Item Name: Crosstube Turning Detail

DART AEROSPACE LTD		Work Order:	105915
Description: Crosstube Assembly (205/212/412 High Fwd)		Part Number:	D212-664-141
Inspection Dwg: D212-664-141 Rev: D		Page 1 of 2

DRAWING NO. D212-664-141	TITLE XTUBE ASSY (205/212/412 HI FWD)	REV. D	DART AEROSPACE LTD ENGINEERING ORDER		D.E.O. NO. D212-664-141-D-1	SHEET NO. SHEET 1 OF 2	SCALE NTS
DRAWN	CHECKED	MP	MFG. APPR.	APPROVED	MP	DE APPR.	
DATE 11.04.07	DATE 11.07.11		DATE 11.04.12	DATE 11/04/12		DATE 11.04.12

DRAWING NO. D212-664-141	TITLE CROSSTUBE ASS'Y (205 HI FWD)	REV. D	DART AEROSPACE LTD ENGINEERING ORDER		D.E.O. NO. D212-664-141-D-2	SHEET NO. SHEET 1 OF 1	SCALE NTS
DRAWN <i>UP</i>	CHECKED <i>ADS</i>	MFG. APPR. <i>ES</i>	APPROVED <i>MP</i>		DE APPR. <i>MP</i>		
DATE 11.07.15	DATE 11.07.20	DATE 11.07.21	DATE 11/07/21		DATE 11.07.21

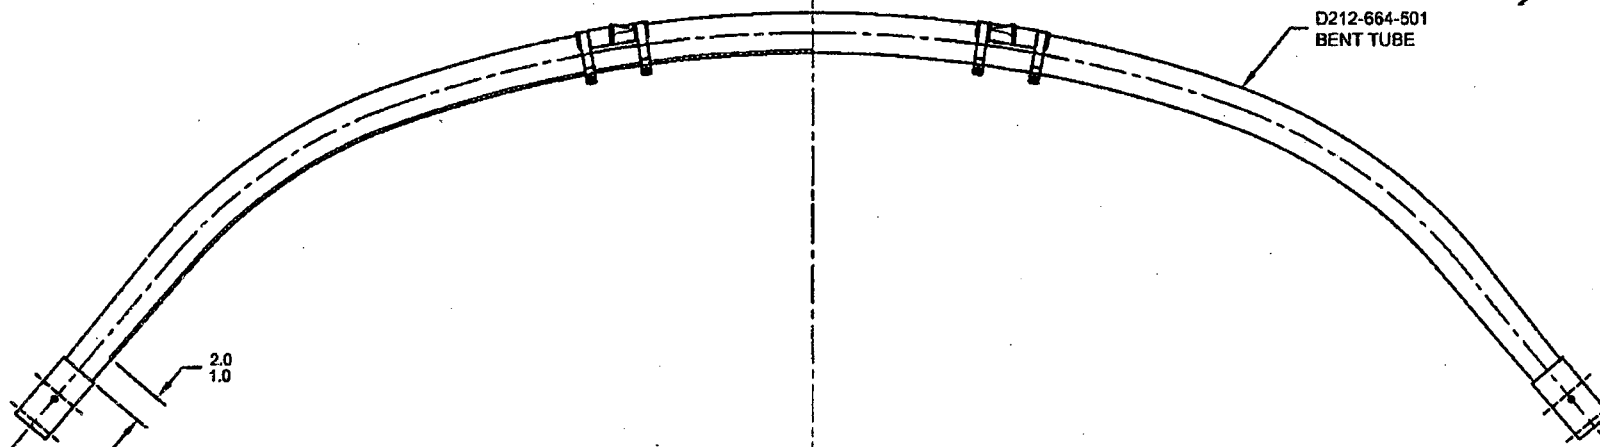
ADD AN INSPECTION WINDOW TO UNDERSIDE OF CROSSTUBE.

MASK AREA PRIOR TO PAINTING,
REMOVE MASKING AFTER PAINT
AND APPLY CLEAR COAT

- 2) FINISH: CHEMICAL CONVERSION COAT PER DART QSI 005 4.1
PRIME INSIDE AND OUTSIDE PER DART QSI 005 4.2
MASK UNDERSIDE OF CROSSTUBE AS SHOWN (HATCHED AREA) AND
PAINT OUTSIDE PER DART QSI 005 4.2
REMOVE MASKING AND APPLY CLEAR COAT
